Submission of Further Information (FI)

**Temporary Place of Recreation, Sports or Culture and Animal Boarding
Establishment with Ancillary Facilities and Associated Filling of Land and Pond
for a Period of 3 Years in “Agriculture” Zone, Lots 1464 (Part), 1466 (Part), 1486 (Part),
1489 (Part) and 1494 (Part) in D.D. 107 and Adjoining Government Land,
Kam Tin, Yuen Long, New Territories
(Application No. A/YL-KTN/1164)**

Further Information for Planning Application No. A/YL-KTN/1164
Response-to-Comments

Plan 6a (P 22034)

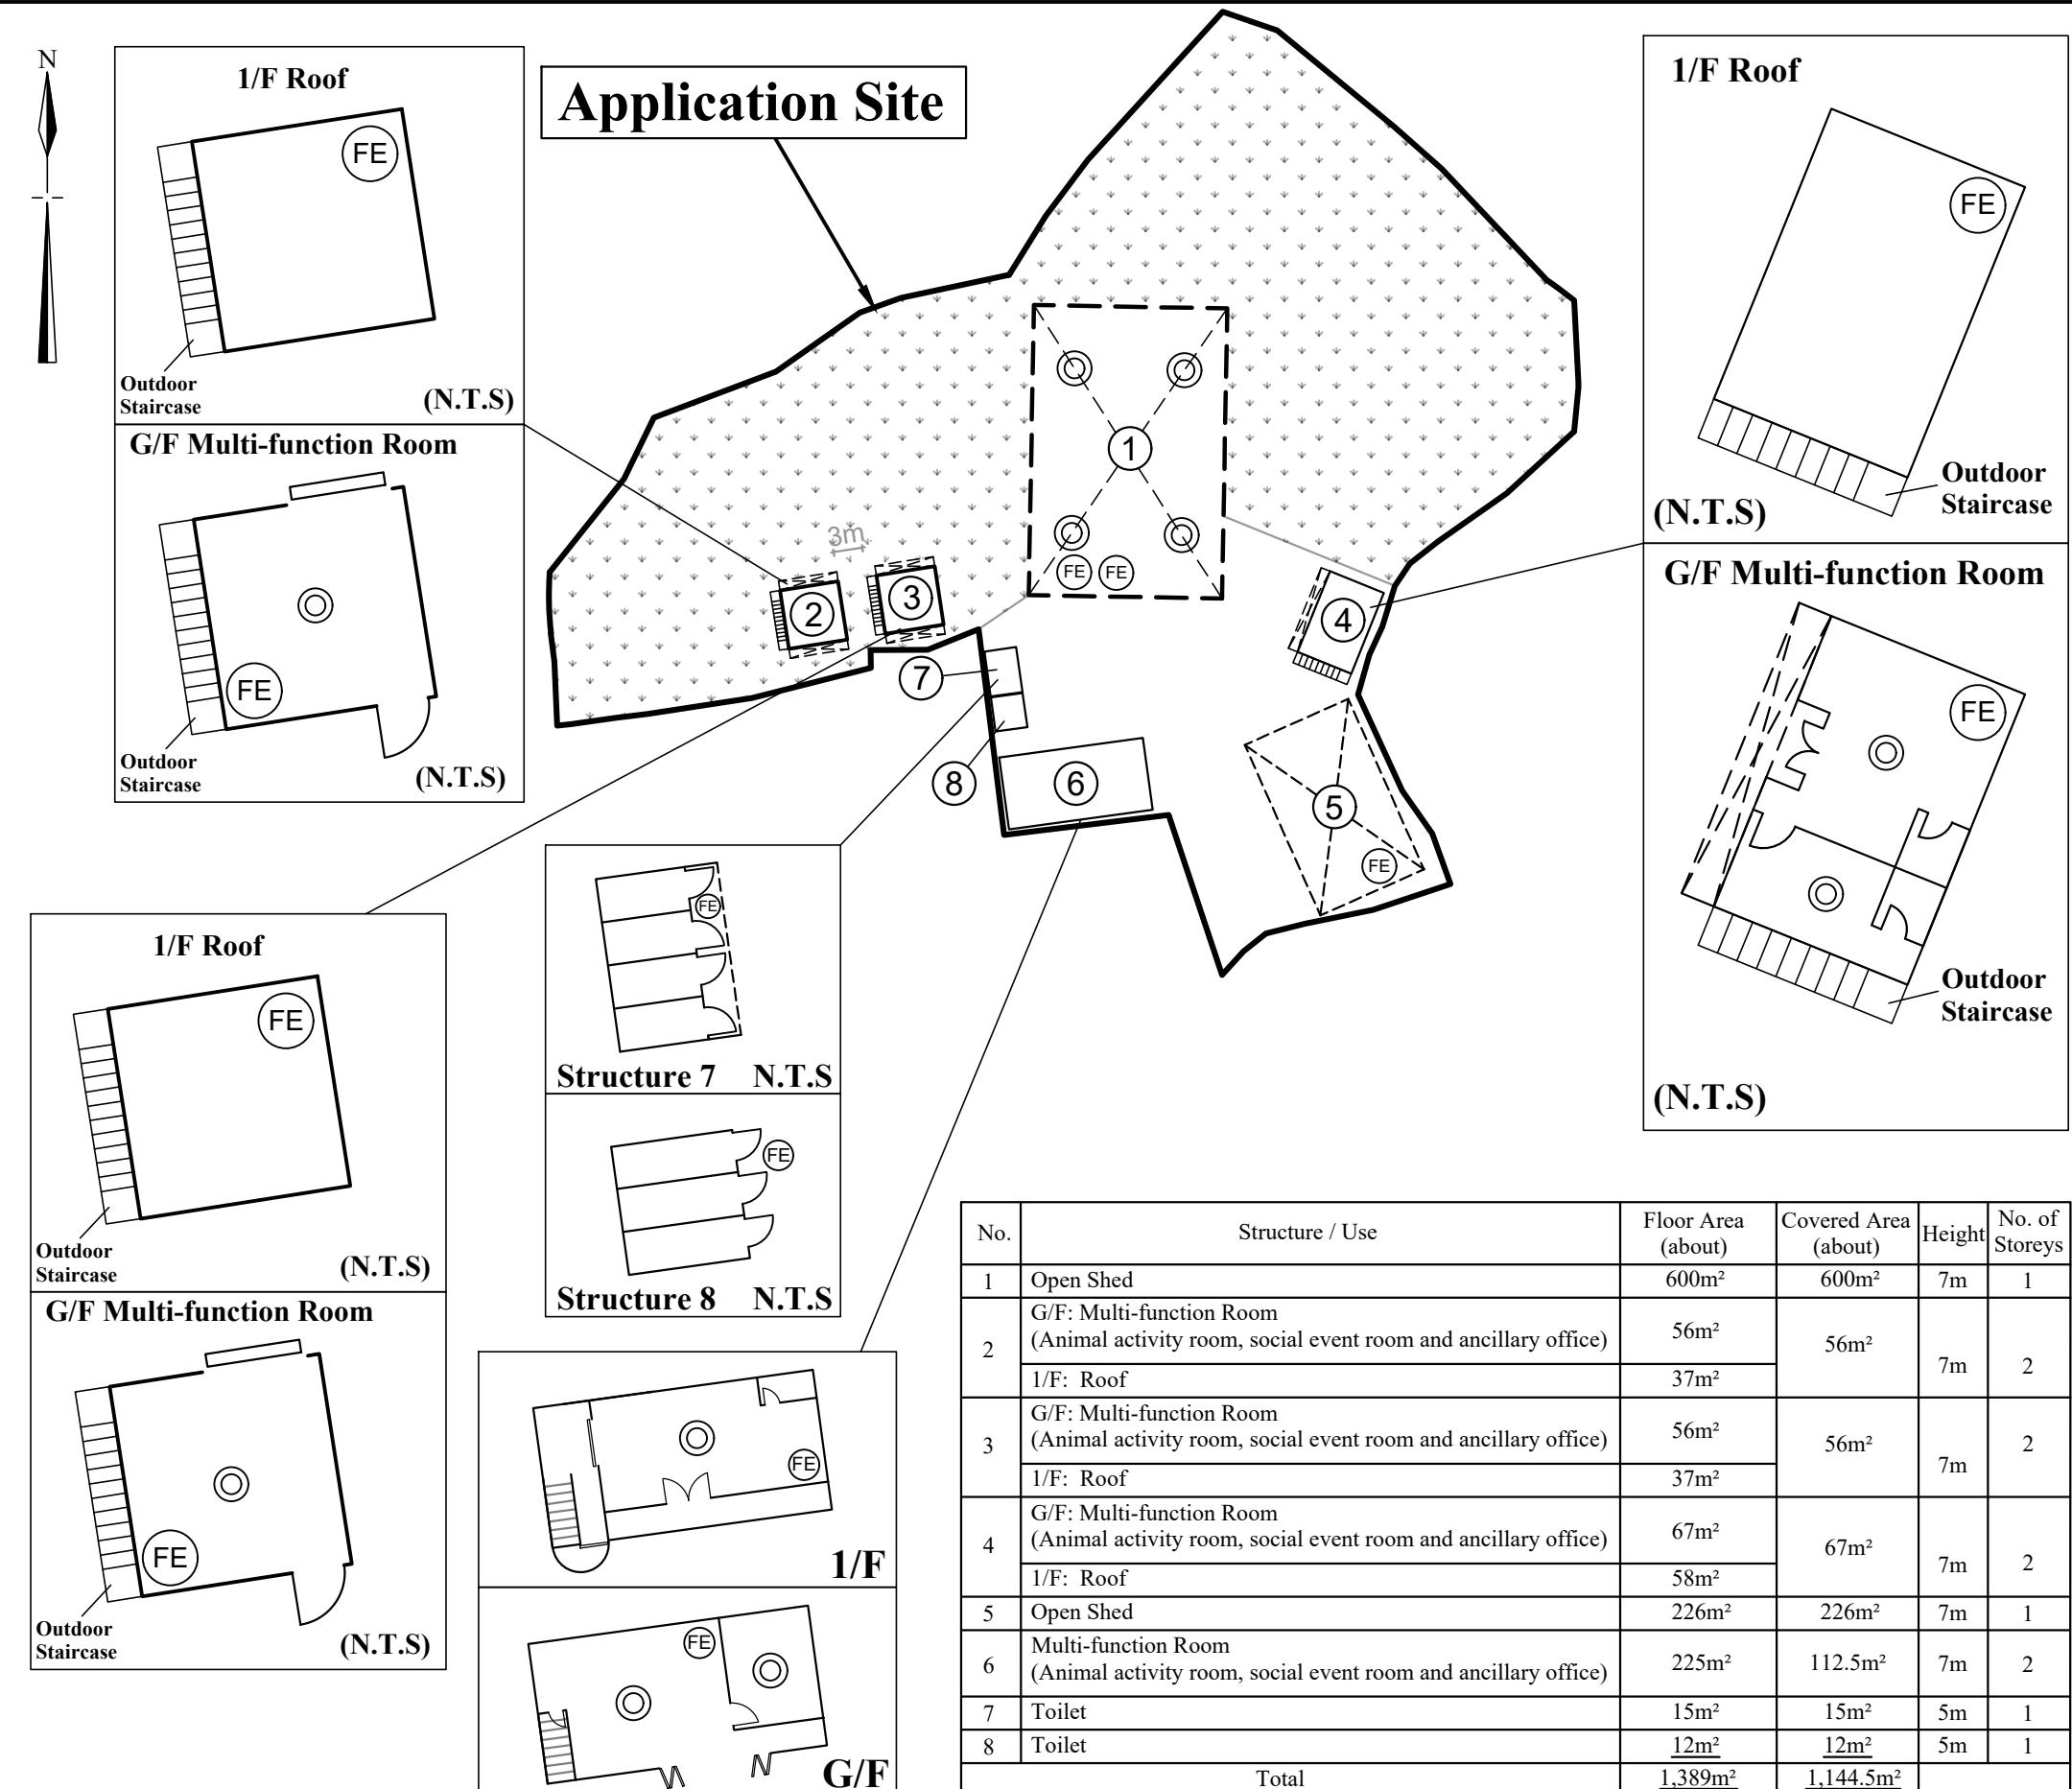
III.	Comments	Responses
1.	i. For enclosed structure with gross floor area not exceeding 230m ² , only fire extinguisher and Stand-alone Fire Detector shall be provided; ii. In relation to i. above, where two or more Stand-alone Fire Detectors are installed in an enclosed structure, all stand-alone detectors shall be interconnected (either wired or wirelessly) such that when one of the stand-alone fire detector is triggered, all connected Stand-alone Fire Detectors shall sound an alarm simultaneously; iii. The Stand-alone Fire Detector shall be provided in accordance with the "Stand-alone Fire	Please refer to the revised FSI proposal (Plan 6a) for details.

<p>Detector General Guidelines on Purchase, Installation & Maintenance [Sep 2021]”;</p> <p>iv. Modified hose reel system, fire alarm system, emergency lighting, directional and exit signs are considered as self-upgrade and not a mandatory requirement by this Department.</p> <p>v. If the applicant self-initiates the provision of directional and exit signs, the standards and specification shall be in accordance with “BS 5266-1:2016 and the FSD Circular Letter No. 5/2008”; and</p> <p>vi. If the applicant self-initiates the provision of modified hose reel system, the standards and specification shall be in accordance with “Code of Practice for Minimum Fire Service Installations and Equipment 2022”;</p>

2.	<p>Please advise the applicant to clarify whether the 1/F of Structures 2, 3 and 4 is a covered area. If yes, Stand-alone Fire Detectors shall be provided.</p>	<p>1/F of structures 2, 3 and 4 is a rooftop and it is not a covered area.</p>
